Re: Initial Submission Review: McDonald's at Eagle Ridge - Conditional Use and Site Plan
Application Number: DA-2338-03
Case Numbers: 2024-6021-00; 2024-6021-01

Initial Submission Review

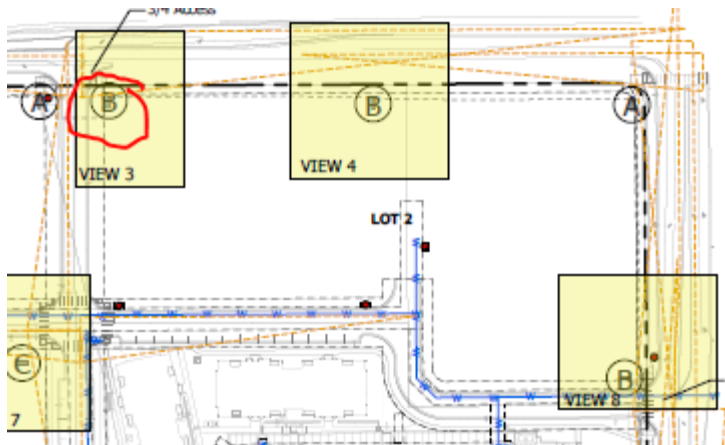
- 6A. Ensure correct permitted signage maximums are included on the Data Block. The sign standards can be found in Code Section 146-4.10. Signage maximums are calculated from the longest building frontage with a public entrance.

- 6B. Note that square footage of the monument (wall) signage is included in the total sign area calculation. Please confirm that the proposed monument signage is included in the (new) calculation, including the height, material, color, and lighting method on the site plan.

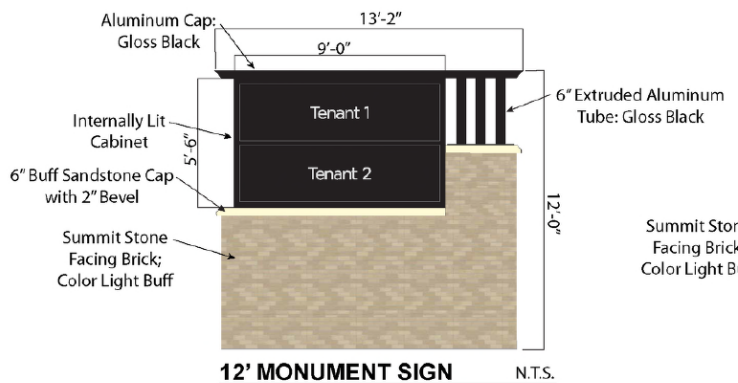
- 6C. Please include the footcandles for the entire site with the second submission.
- 6D. The Eagle Ridge Master Sign Program does not allow additional monument signs along Stephen D Hogan for individual users. If this site intends to add tenant signage to the approvement monument sign for the development please clarify. Below is a detail of the approved monument sign and location per the master sign plan.
